MOORE PUBLIC SCHOOLS -
ASC BOARDROOM and STORM SHELTER BUILDING
Moore Public Schools - Moore, Oklahoma
AGP - Moore, Oklahoma

ADDENDUM NO. 2
November 4, 2026

1 E. WALL ROOM # 2
1/4" = 1'-0"

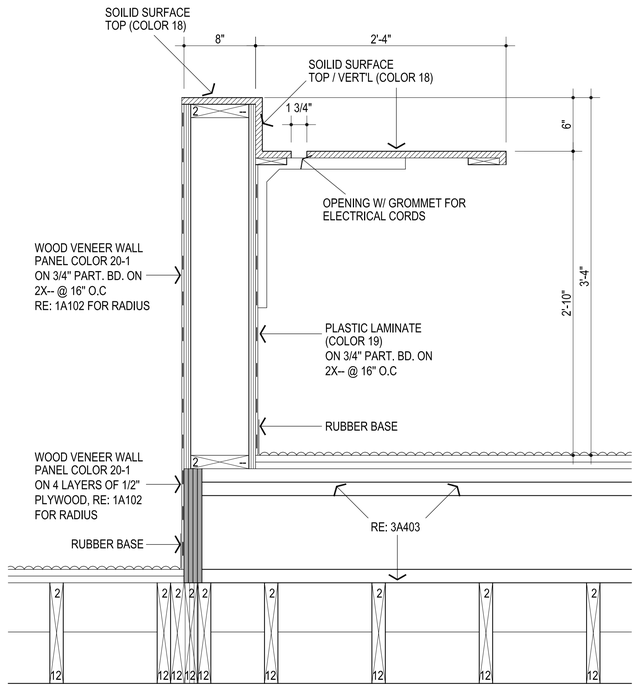
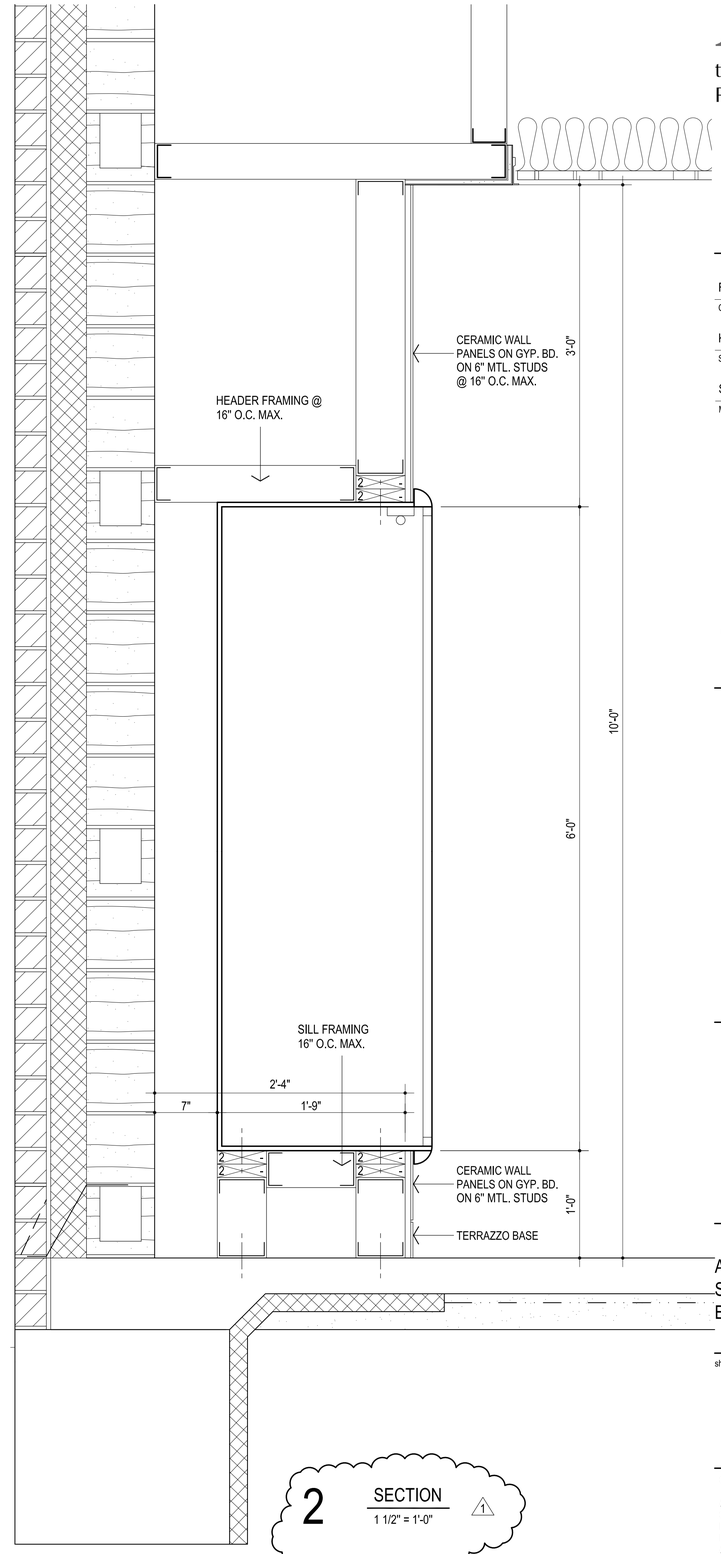
16. Sheet A701, Detail #1, East Wall Room #2 / Detail #2, Section / Detail #3, Section at Counter: revise display cabinets and school board counter as indicated. Refer to new attached replacement drawing.
